Mount Pleasant Coal Project - DA 92/97 Modification 3
Lodged by MACH Energy Australia Pty Limited (MACH) on 16 June 2017
Submission by Bengalla Mining Company Pty Limited

14 July 2017

MOUNT PLEASANT OPERATION
MINE OPTIMISATION
MODIFICATION

**Response
to Submissions**

MINE PLAN - YEAR 2

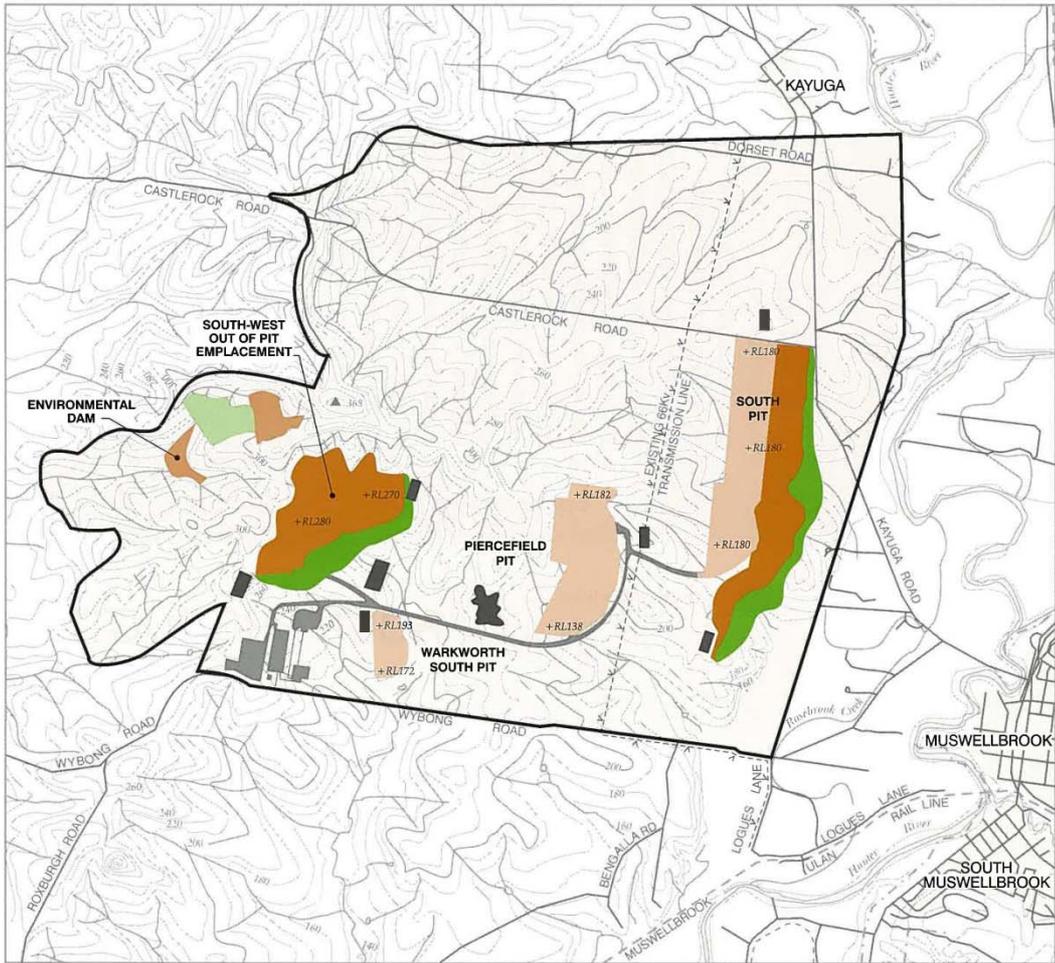
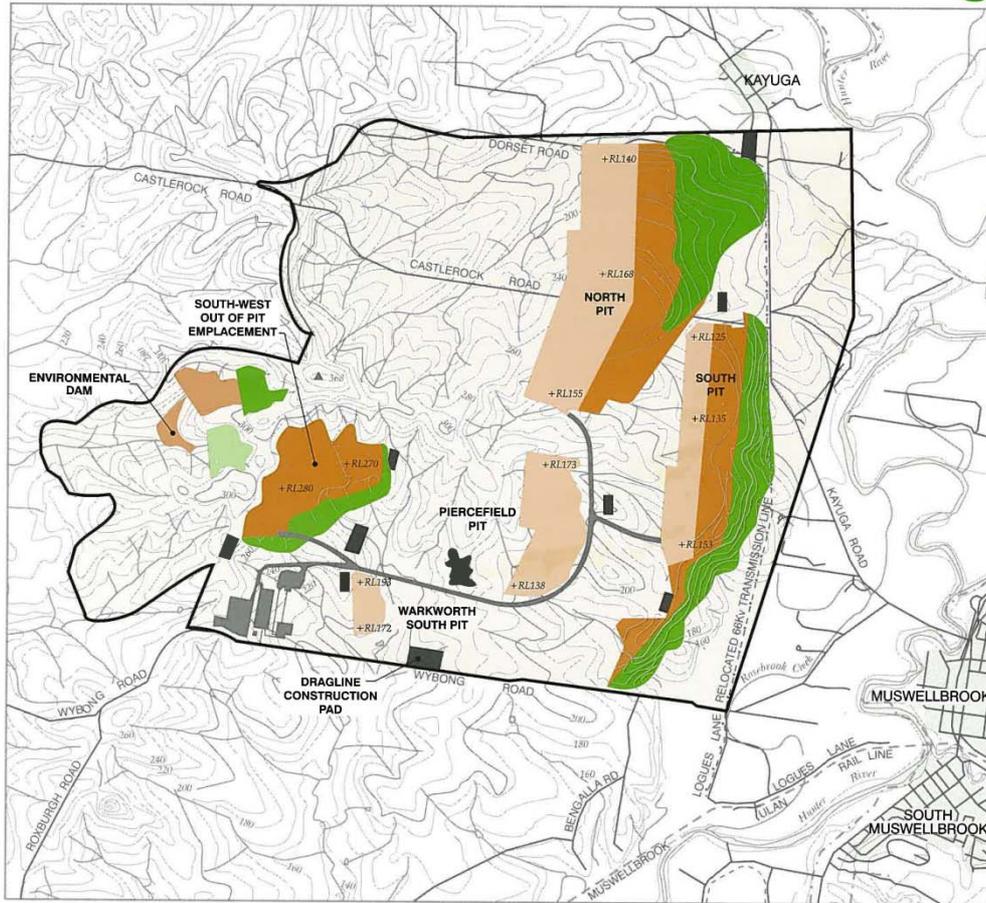
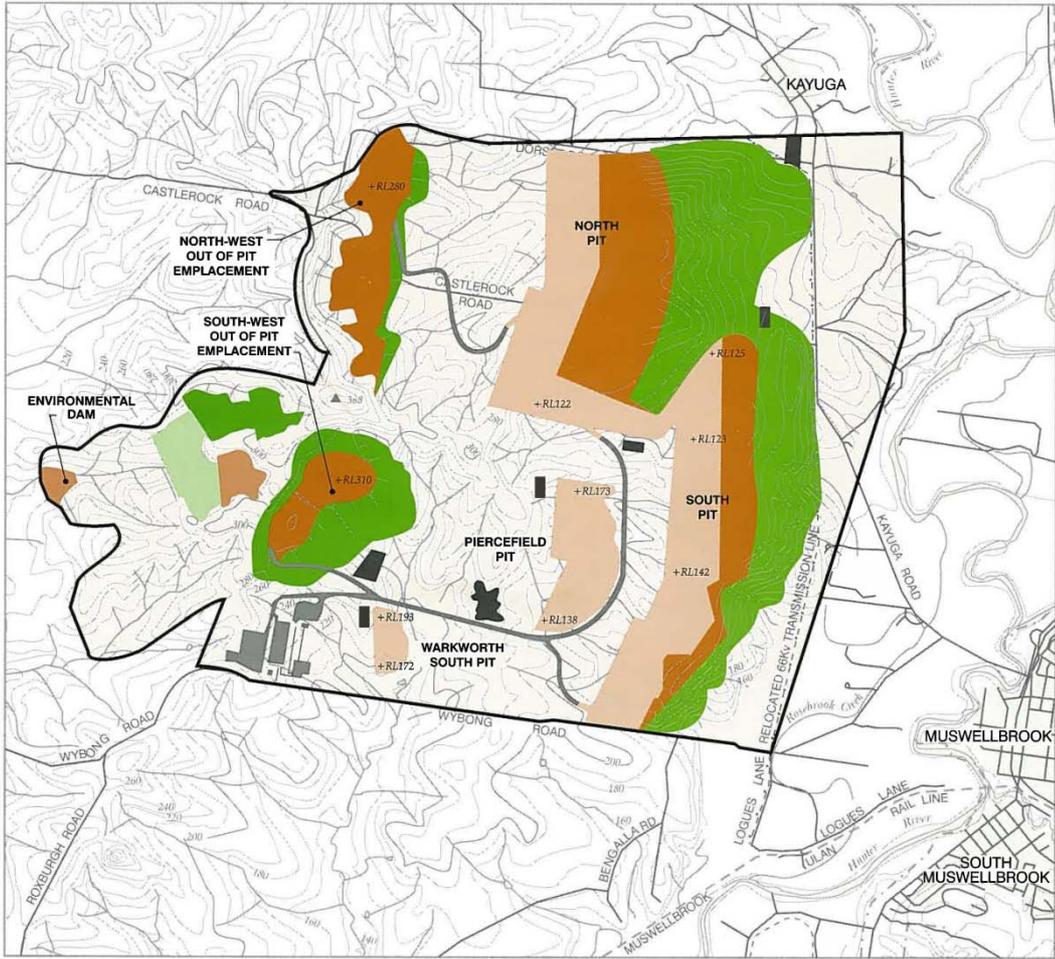
9 and 10 (copies **attached as Appendix 1**) from the original Mount Pleasant Environmental Impact Statement clearly show mining occurring between years 2 and 5 and thereafter within North Pit for what would be a material proportion of the total coal mined during those years. The presence of North Pit in the existing approval is acknowledged by the Director-General's Assessment Report in connection with Modification 1 to DA 92/97, specifically Figure 8 on page 17 of the report (attached to this submission as Appendix 2).

The mining under the proposed modification appears to exclude any mining in North Pit at any time during the development. This is evident from Figure 12 of the EA which is entitled "*Mount Pleasant Operation Provisional General Arrangement 2025*" and Figure 32 entitled "Conceptual Final Landform" on both of which North Pit has abstrusely disappeared.

<p><i>(a) The absence of any mining in "North Pit" (see Figures 10, 11 and 12);</i></p>	<p>Refer MACH Energy's response to BMC Comment 3.3(a).</p>
<p><i>(b) Changes to mine sequencing and flexibility sought in that regard;</i></p>	<p>Refer MACH Energy's response to BMC Comment 3.3(b).</p>
<p><i>(c) Changes to the final landform at Mount Pleasant and potential to cause change to the final landform at Bengalla;</i></p>	<p>Refer MACH Energy's response to BMC Comment 3.3(e).</p>
<p><i>(d) Reduction in total coal extraction and associated economic impacts;</i></p>	<p>Refer MACH Energy's response to BMC Comment 3.3(f).</p>
<p><i>(e) Changed context (namely maintaining MTP South Infrastructure for the 6 year period after December 2020) and different impacts of that.</i></p>	<p>Refer MACH Energy's response to BMC Comments 3.3(i) and 3.3(j).</p>
<p>4.2 <i>No quantification of water take</i></p> <p><i>There does not appear to be any quantification of the volumes of water which will be extracted from each of the water sources which will be (directly or indirectly) affected by the development or any evidence of how much licensed water entitlement will be required to be held to satisfy that take and whether that entitlement is held.</i></p>	<p>The Mod 3 EA states the following (Section 4.8):</p> <p><i>The Modification would not result in a material change to the groundwater and surface water impacts of the approved Mount Pleasant Operation, given the Modification would not:</i></p> <ul style="list-style-type: none"> <i>• significantly alter the approved general arrangement of the Mount Pleasant Operation;</i> <i>• significantly increase the development area of the mine;</i> <i>• increase the approved annual maximum ROM coal and waste rock production rates; or</i> <i>• include any significant changes to the approved water management system at the site.</i> <p>The Mod 3 EA also states the following with respect to water licensing (section 4.8.3):</p> <p>Water Licensing</p> <p><i>MACH Energy is required to hold water access licences to account for groundwater inflows, incidental groundwater take and groundwater pumped for water supply from aquifers regulated by the Water Sharing Plan for the Hunter Unregulated and Alluvial Water Sources 2009 and Water Sharing Plan for the North Coast Fractured and Porous Rock Groundwater Sources 2016.</i></p> <p><i>MACH Energy's groundwater licensing requirements will ultimately be determined by the contemporary groundwater modelling being undertaken by HydroSimulations. In the interim, the Water Management Plan presents conservative estimates of MACH</i></p>

Figure 1

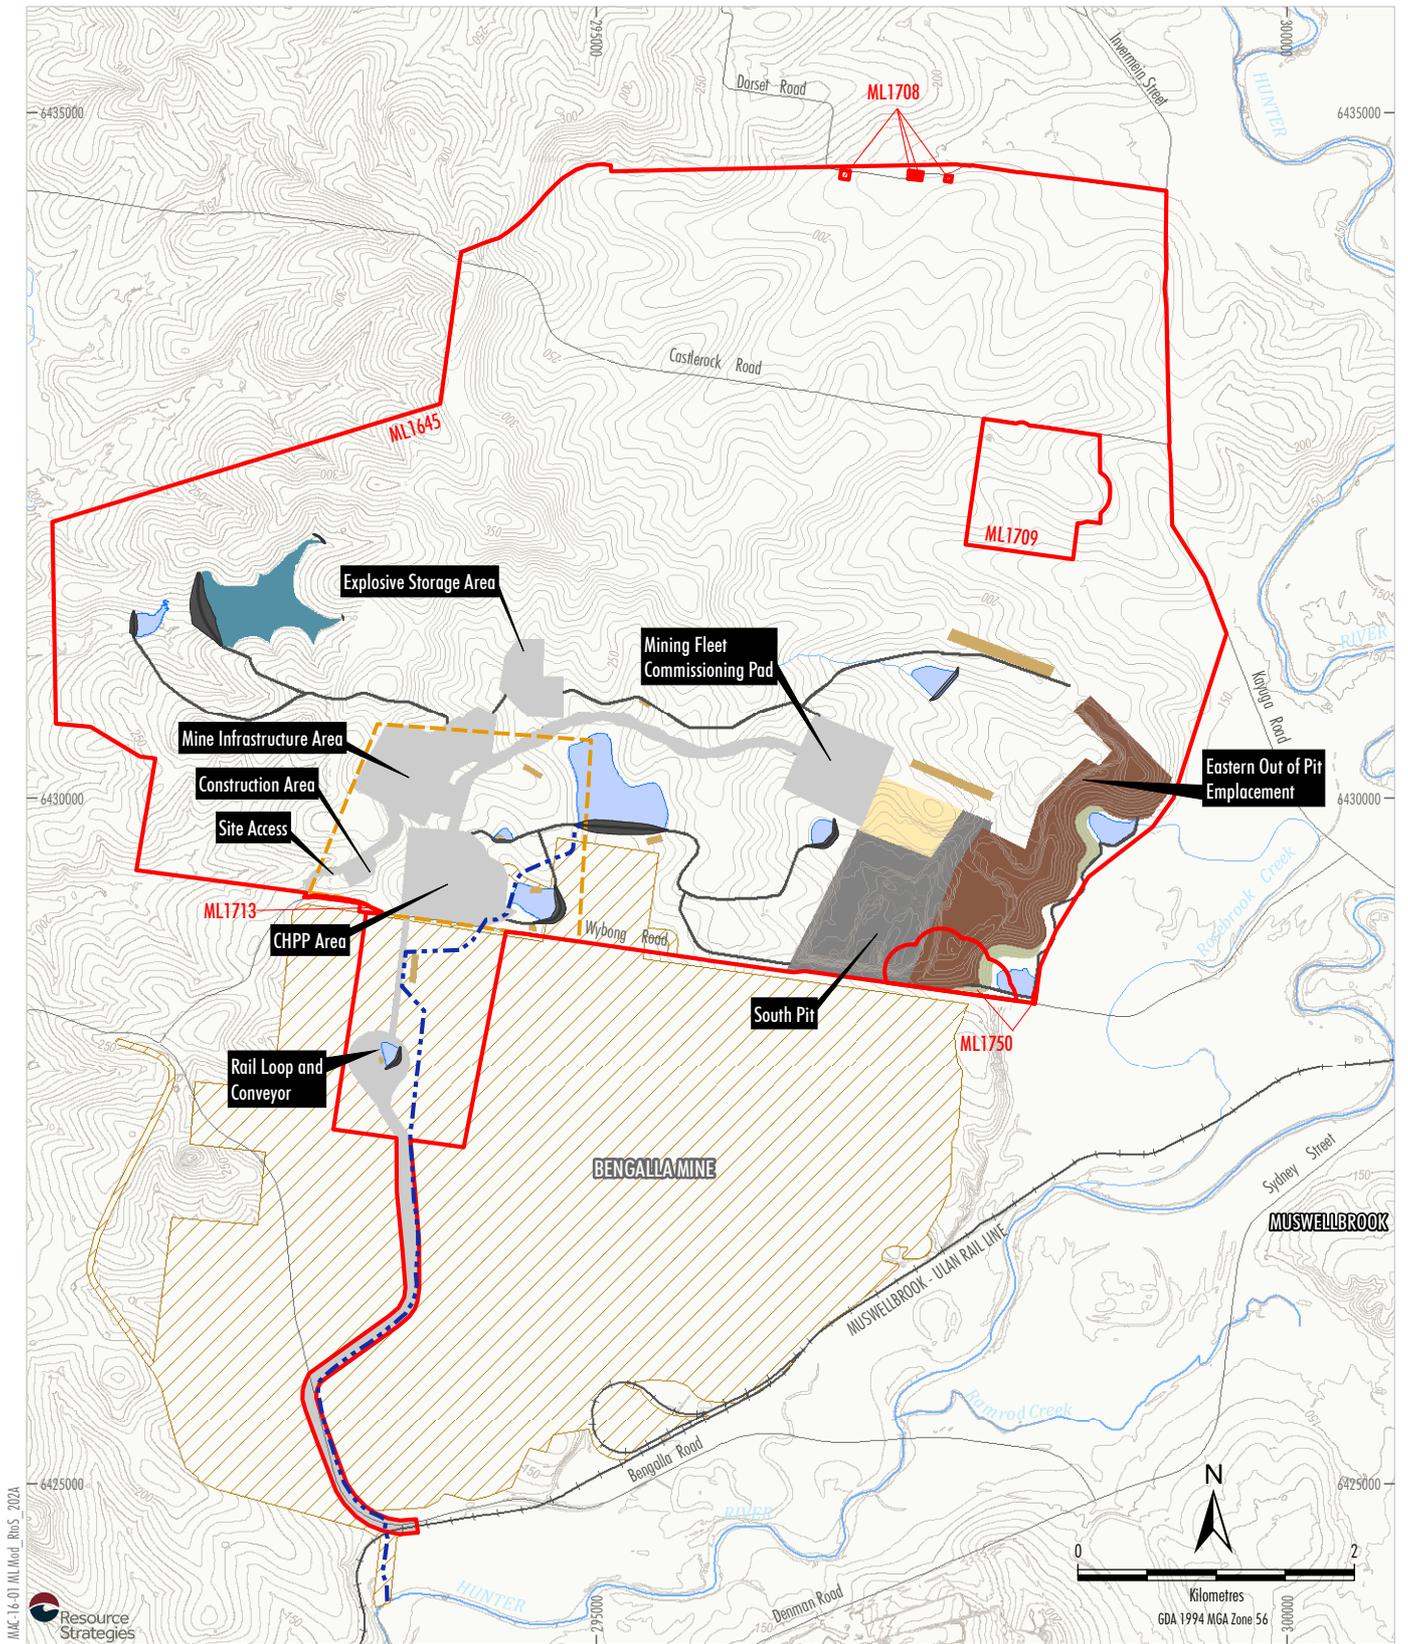
An updated version of the 2018 Provisional General Arrangement (Figure 10 of the Environmental Assessment) is provided as Figure 1. This figure corrects a minor inconsistency between the Environmental Assessment and the supporting appendices to show the initial rehabilitation on the eastern face of the Out of Pit Emplacement in 2018. This correction makes the 2018 Provisional General Arrangement consistent with the Air Quality Assessment and Site Water Balance Review assessments presented in the Environmental Assessment that included this initial rehabilitation.

Figure 1: Indicative mine plan for Scenario 1 with modelled source locations

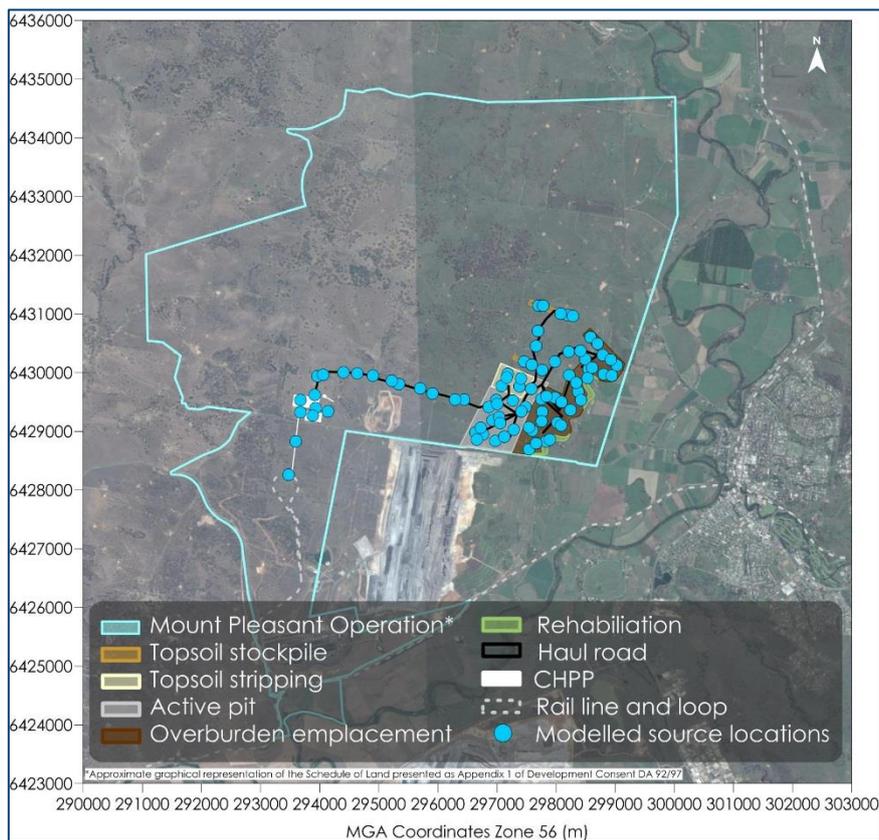
<p><i>When comparing the indicative mine plan in the EA with AQA Scenario 1 (2018), the AQA shows an area of rehabilitated land that is not shown in the EA.</i></p>	<p>Figure 5-2 of the AQA and Figure 1 present the proposed area for rehabilitation for Scenario 1.</p>
<p><i>With the exception of the difference in the boundary noted above, the indicative mine plans for 2021 and 2025 appear to be similar in both the EA and AQA. However, without detailed information on the location of source, it is not possible to determine if activities have been accurately represented in the AQA.</i></p>	<p>Refer to Figure 2 to Figure 3.</p>
